CITY OF ALAMO HEIGHTS

Request for Proposal (RFP)
for
General Construction for the Alamo Heights Pool
Pocket Park

Addendum 1

Revision Narrative – Addendum 01

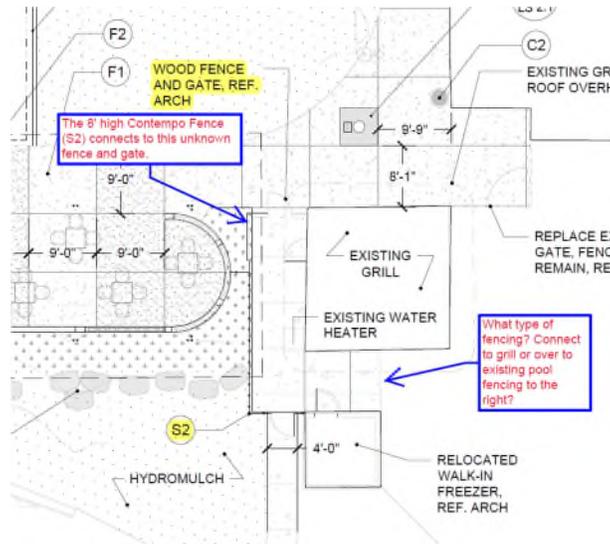
Q4. C1.1 "E. Refrigerator to be relocated (coordinate with cooler manufacturer)." S2.01 does not show a new concrete slab at the new location. If one is required, please provide details.

A4. Pending manufacturer recommendations, but the new slab does not need to be specifically engineered. A 4" slab at 2,500lbs capacity would suffice with 2" rigid insulation below slab for insulation.

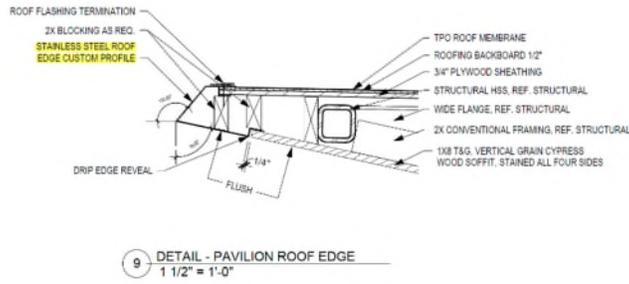
Q8. LP1.1 – The brick planters around the trees near the front of the building will be removed. The dirt level is much higher than the surrounding concrete. The planting plan shows the millstones around approximately 2 sides and planting under the trees. Are we to slope the dirt down to concrete level? We are concerned tree roots could be exposed and possible erosion.

A8. The plans are showing walls to remain at the 2 sides of each tree well where the existing sidewalk is staying in the same location. The other two sides of each tree will have additional planting space for what is there today, and the soil should be sloped to meet grade.
